PROJECT DESCRIPTION

DESIGN DEVELOPMENT

PRIORITIES & BOARD RECOMMENDATIONS

BOARD RECOMMENDATION

LANDSCAPE PLAN AT GROUND LEVEL

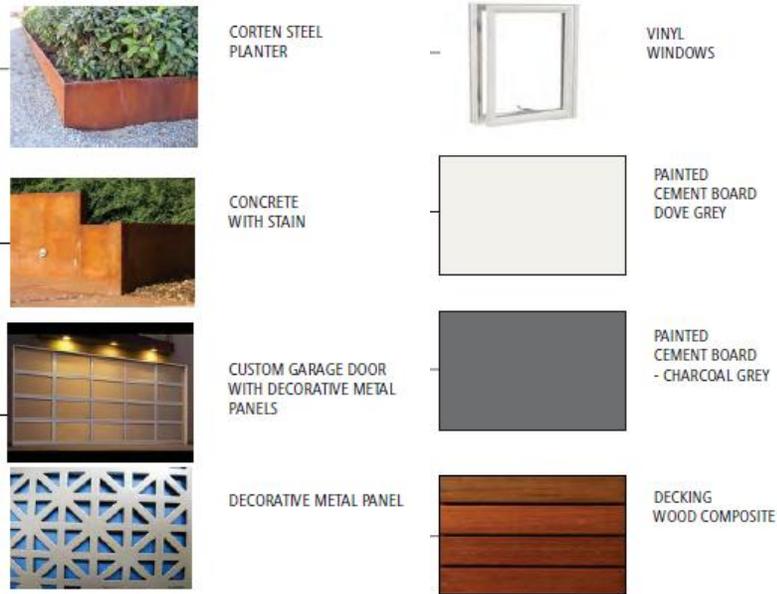
At the Final Recommendation Meeting, the Board expressed support for the efforts to minimize impacts to privacy of adjacent neighbors, such as off-set windows, frosted glass where windows are not off-set, and tall landscaping at the north and south property lines.

At the Final Recommendation Meeting, the Board expressed some concern about the proposed use of bamboo at the north and south property lines, and the potential for this plant material to spread and cause damage to nearby structures. The Board

recommended a condition to use containers or impermeable barriers to prevent bamboo roots from spreading and causing damage.

1. The proposed development shall include an area designed for storage of solid waste bins on collection days, where the bins will not obstruct the sidewalk. (D-6)
2. Any bamboo shall be non-spreading variety, or planted with containers or barriers to prevent spreading roots. (E-1, E-3)
